2205651
 Forest Creek
 Upper Floor
 18" Depth
 19.2" OC

SHOP DRAWING / SUBMITTAL REVIEW

Project # 2205651	Date: 11/28/2022	 360.384.9000
Sales: Daniel Turner	Name: SEASCAPE HOMES Forest Creek	
dturner@lowstruss.com	5214 Forest Ave SE MERCER ISLAND WA 98040	
Roof area: 0 sq ft	Sub.: Lot: #

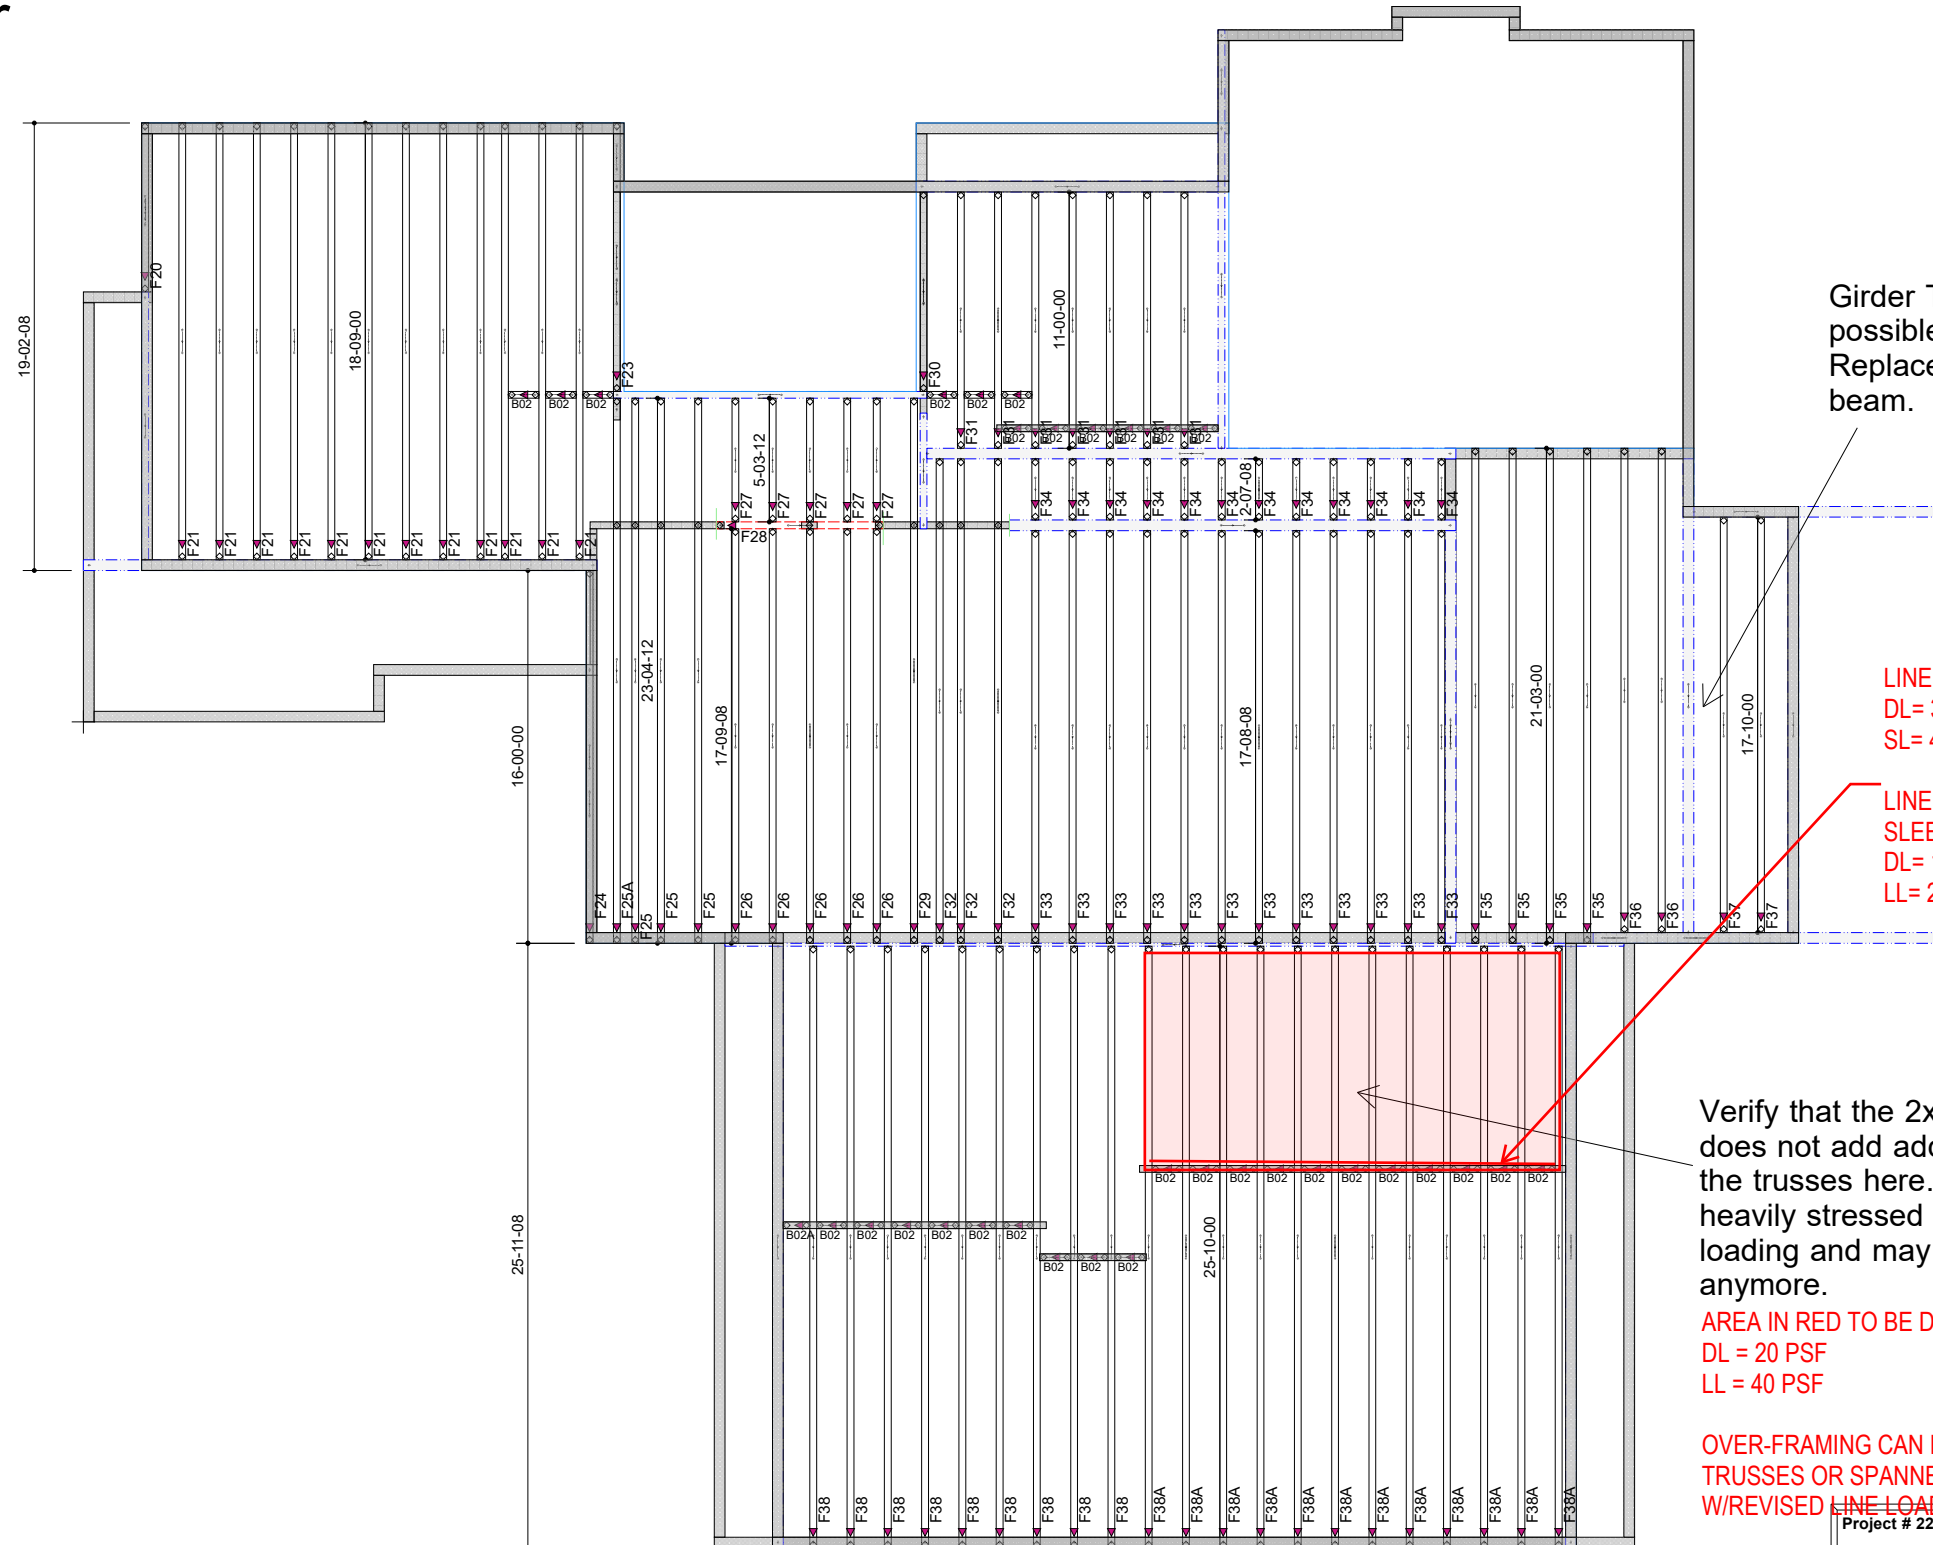
Girder Truss not possible here. Replace with beam.

Verify that the 2x10 overframing does not add additional loading to the trusses here. The trusses are heavily stressed due to the existing loading and may not function with anymore.

LINE LOAD FROM BEARING WALL ABOVE:
 DL= 350 PLF
 SL= 415 PLF

LINE LOAD FROM OVER-FRAMING IF NOT USING SLEEPER SYSTEM:
 DL= 100 PLF
 LL= 200 PLF

AREA IN RED TO BE DESIGNED FOR:
 DL = 20 PSF
 LL = 40 PSF

OVER-FRAMING CAN BE PLACED ON SLEEPER SYSTEM DIRECTLY OVER FLOOR TRUSSES OR SPANNED OVER FLOOR TRUSSES BETWEEN LEDGER & PONY WALL
 W/REVISED LINE LOAD AS SHOWN

2205651
 Forest Creek
 Lower Floor
 18" Depth
 19.2" OC

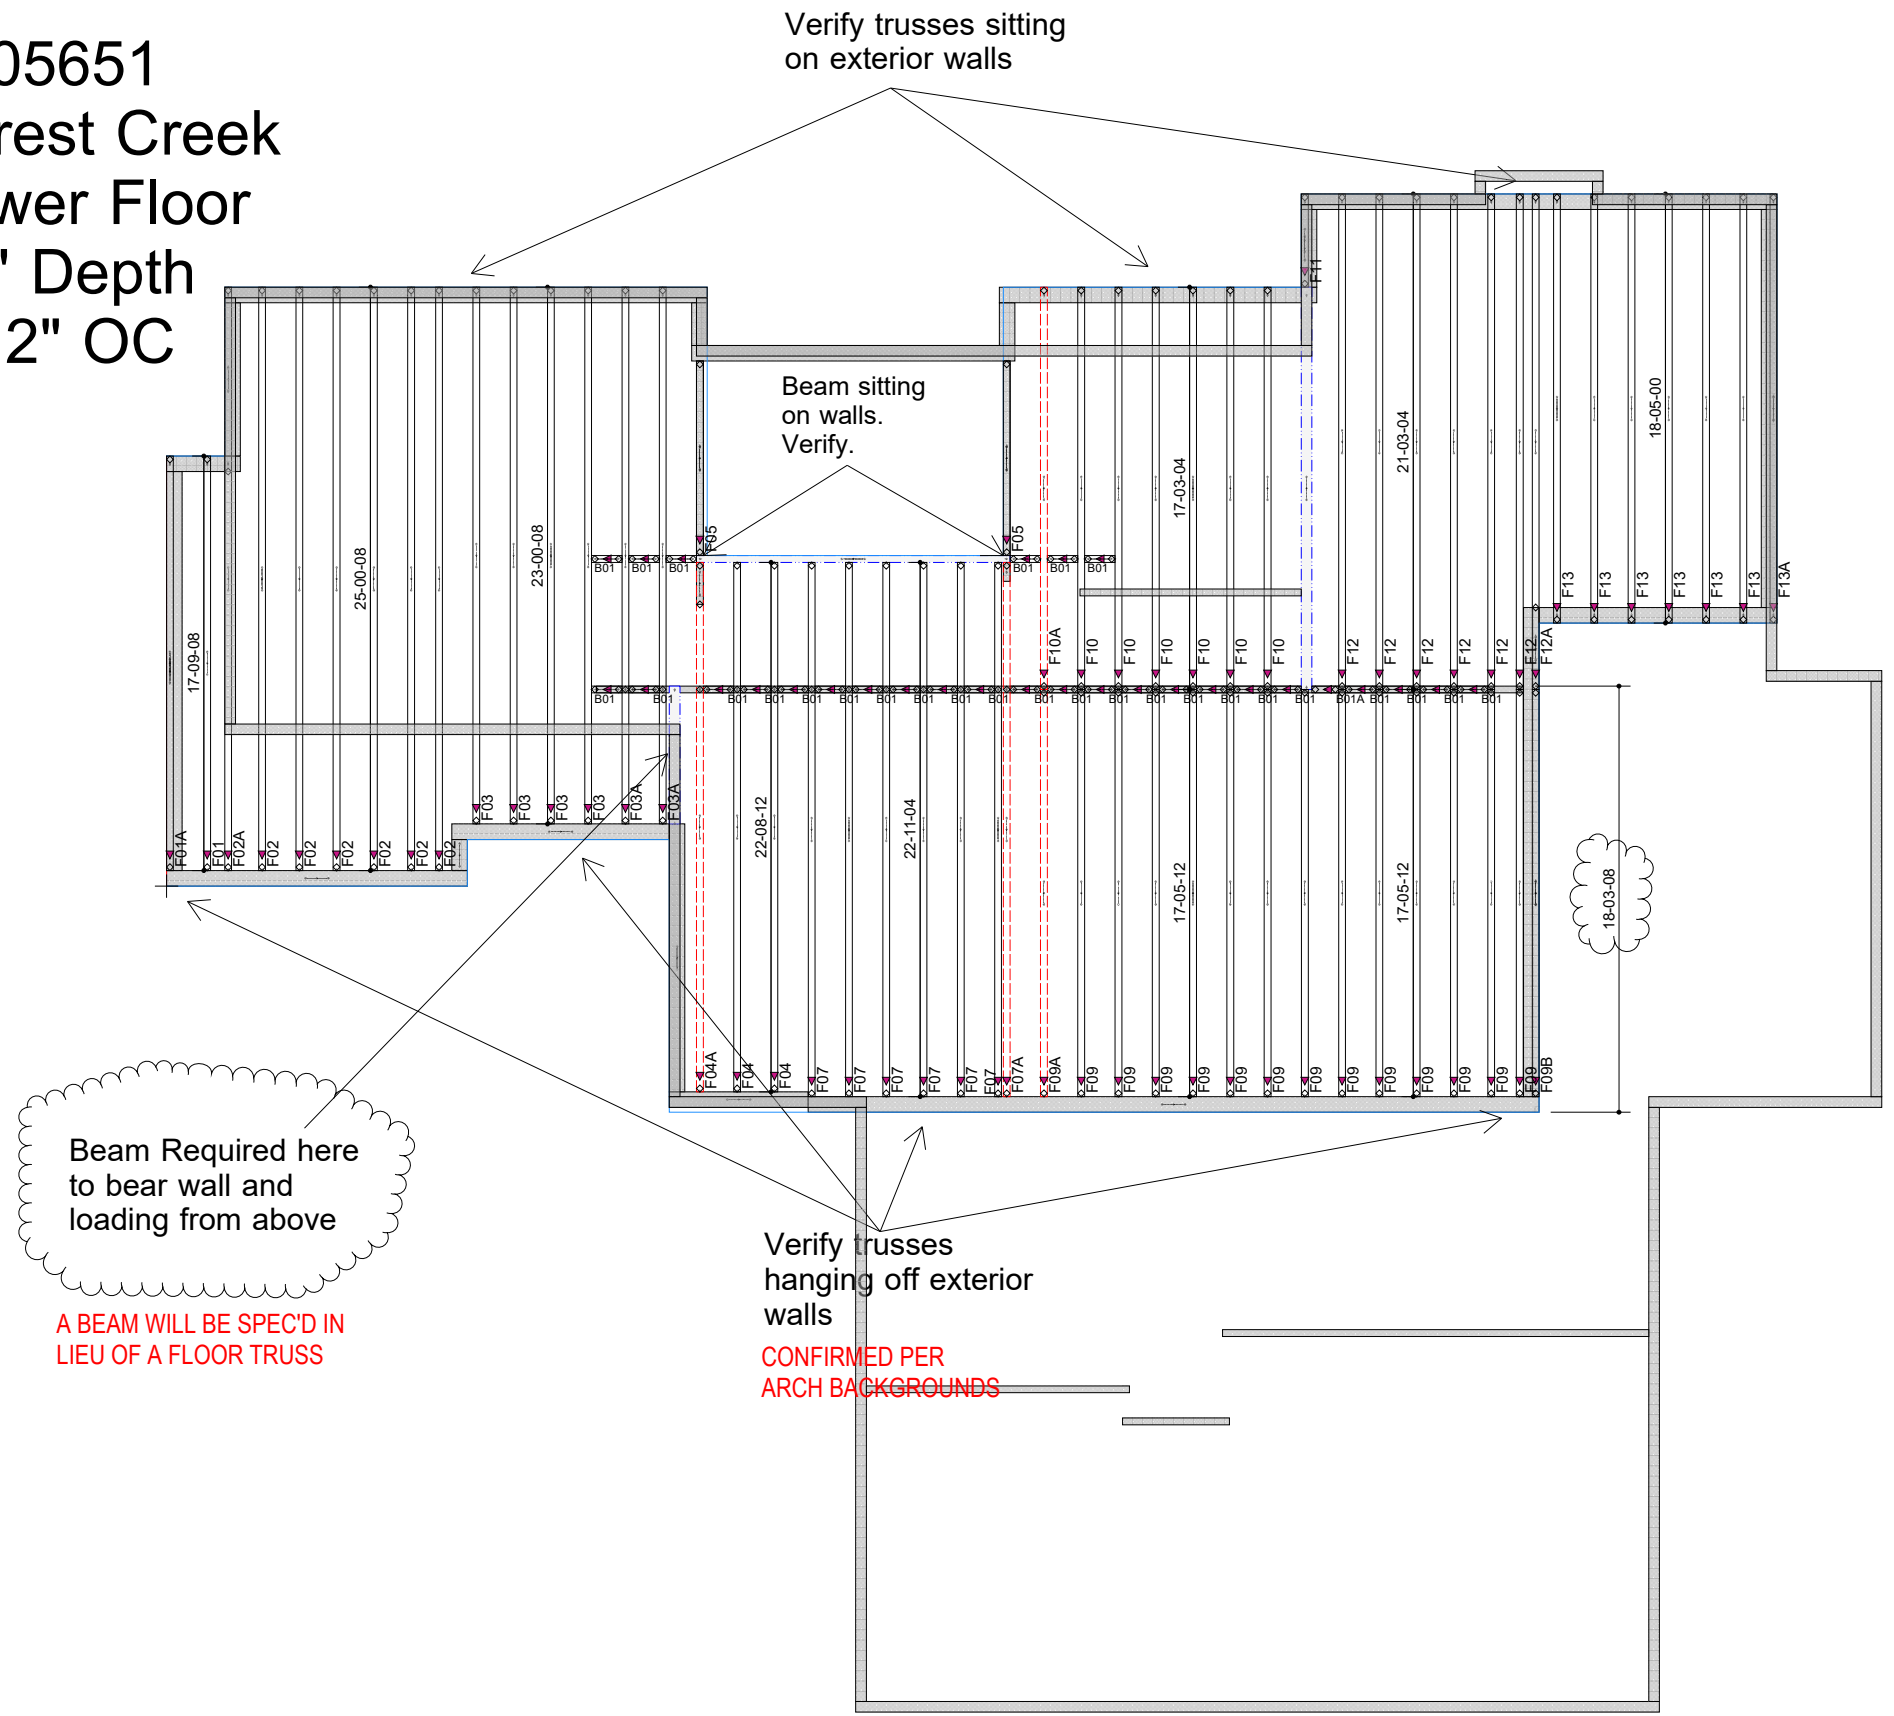
Beam Required here to bear wall and loading from above
 A BEAM WILL BE SPEC'D IN LIEU OF A FLOOR TRUSS

Verify trusses hanging off exterior walls
 CONFIRMED PER ARCH BACKGROUNDS
